**CITY OF SARATOGA SPRINGS
CITY COUNCIL WORK SESSION AGENDA**

Tuesday, February 16, 2016

Author: Kara Knighton, Planner I
Memo Date: Tuesday, February 9, 2016
Meeting Date: Tuesday, February 16, 2016
Re: Grandview Commons Rezone, General Plan Amendment, and Concept Plan

Grandview Commons
 Mountain Valley Ventures, LLC
CONCEPT - SITE PLAN

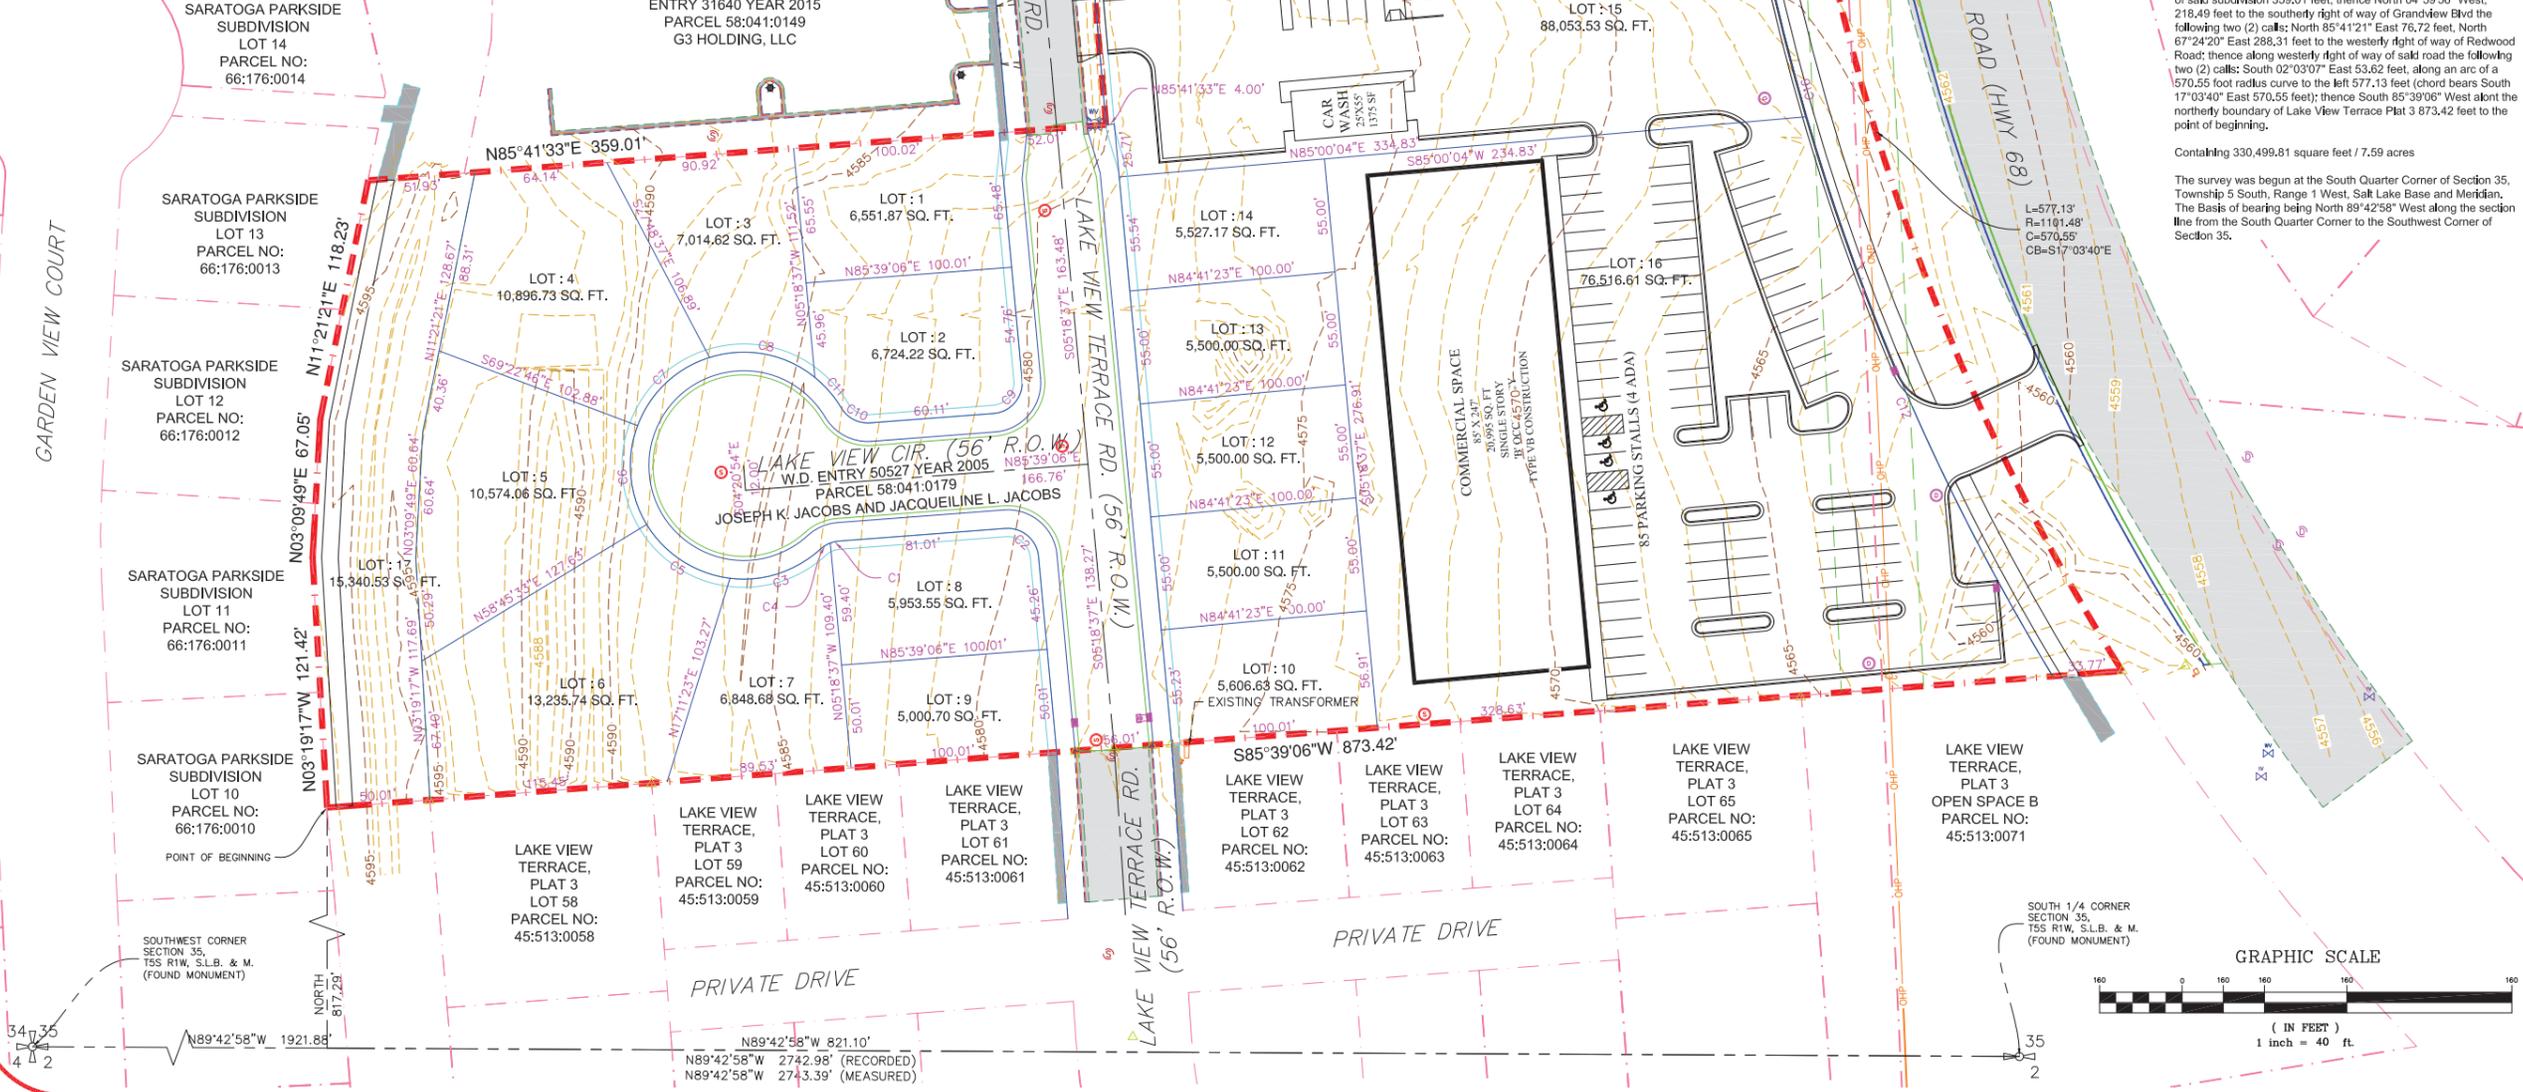
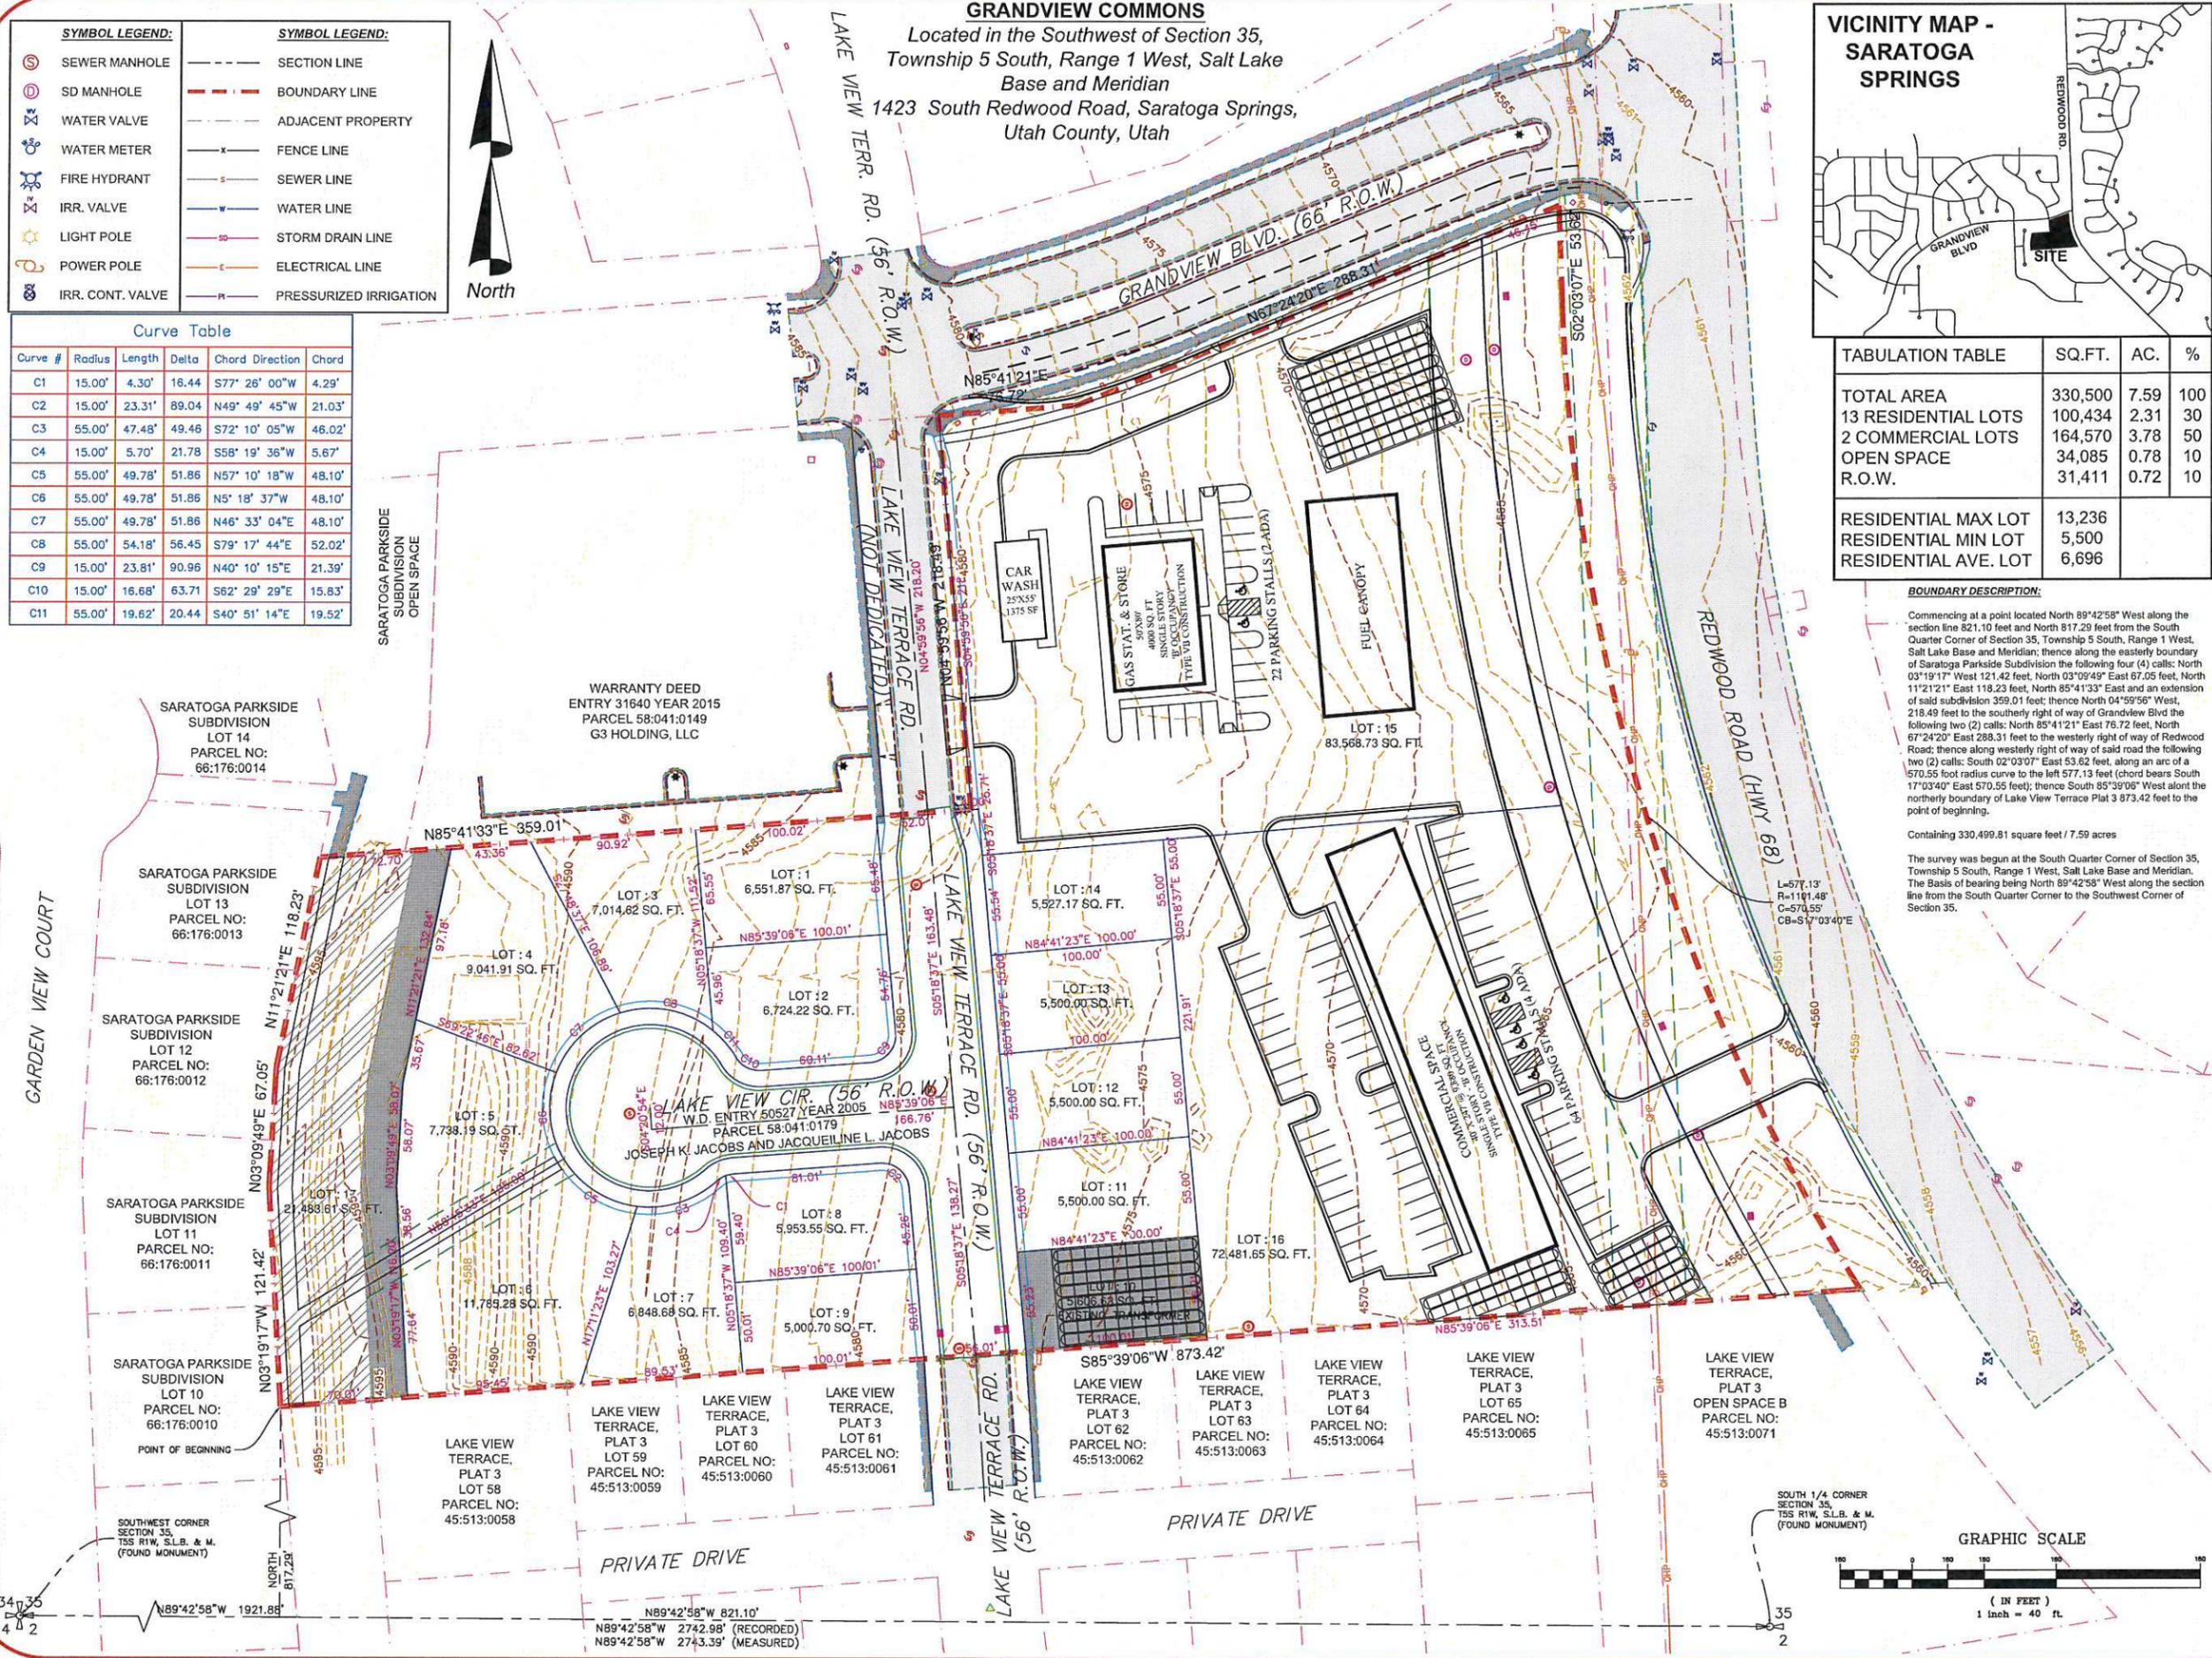
As proposed, each use is currently short in its open space/ landscaping requirements. The R-10 and RC zones require 20% open space/ landscaping, while the NC zone requires 25% of the parcel to be landscaping, however the overall proposed open space is 10%. The canal is considered sensitive lands and may only comprise 50% of the open space requirement for the residential development.

Lake View Terrace Road is currently not a public road. A road dedication was required with a previous development but was never finalized; this dedication must be done in order to provide a secondary access to the residential lots, or proof of access easement provided.

The proposal includes full access from Lake View Terrace Road, a right-in right-out on Grandview Blvd., and potential full access on Redwood Road pending UDOT approval. Traffic at Grandview and Redwood has been of significant concern in recent months; the applicant intends timing of their development to occur along with the widening of Redwood. A traffic study will be provided with any future plat and site plan applications, and other traffic mitigation may be required.

Staff recommends that the Planning Commission review and discuss the proposal and give the applicant informal feedback on the proposed rezone, General Plan amendment, and concept plan.
